**North West Priority Growth Area - Land Use and Infrastructure Implementation Plan**

## **Blacktown City Council submission**

### **Land Use and Infrastructure Implementation Plan Draft State Environmental Planning Policy (Sydney Region Growth Centres) 2006 Development Control Plan**

**Examples of inconsistencies between the Proposed Residential Density Map and statements in the Explanation of Intended Effect**

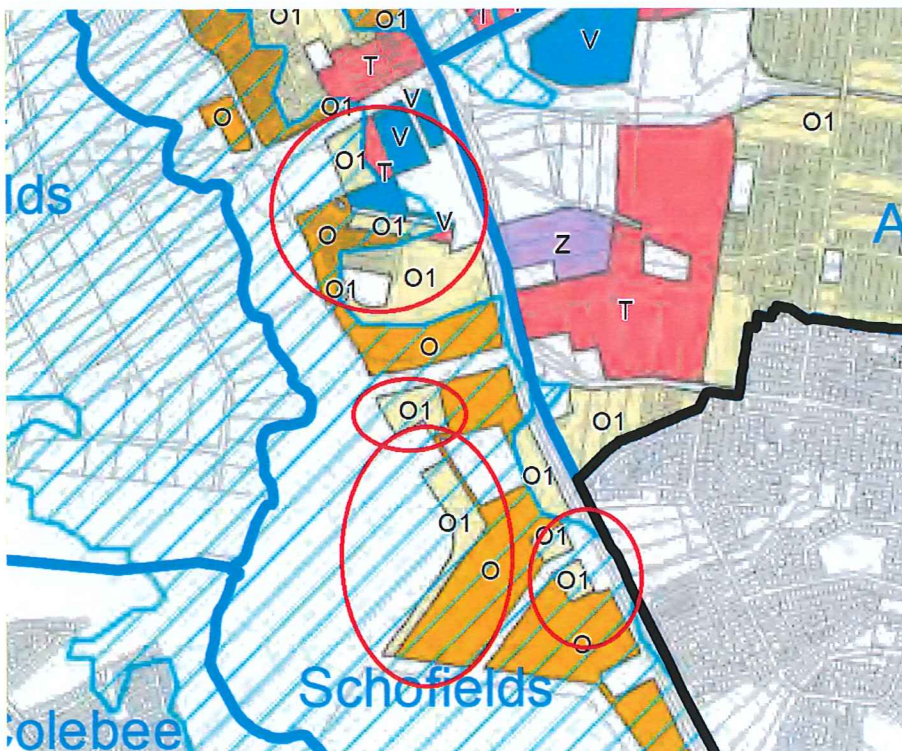
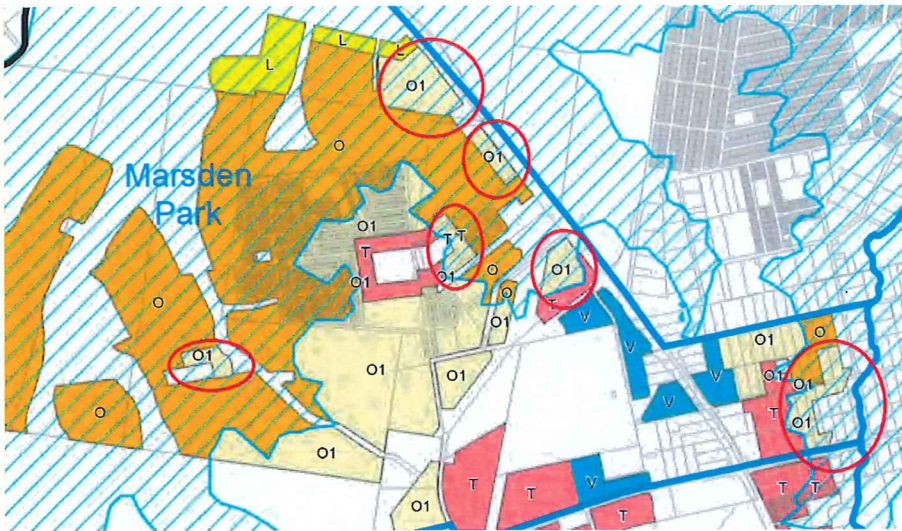
- The table on page 9 of the EIE does not include the density band of 15-20 (dwg/ha) that is shown on the map titled Proposed Residential Density Ranges. It is presumed that this density range applies to land zoned R2 below the PMF.

- The proposed density map shows the density range of 15-25 (dwg/ha) on land zoned R3 Medium Density Residential on the Proposed Land Zoning map, which is also below the PMF. This is inconsistent with the statements in the EIE.

- There is also no density range on the map or in the EIE for R3 Medium Density Residential zoned land below the PMF, yet there are locations where this occurs. Should there be a density range of 25-30 (dwg/ha) for R3 zoned land below the PMF?

- The EIE also does not explain the density range 35-55 (dwg/ha) that is shown on the density map.
- (iii) Notated maps are included as an appendix to highlight some examples of where these inconsistencies occur.
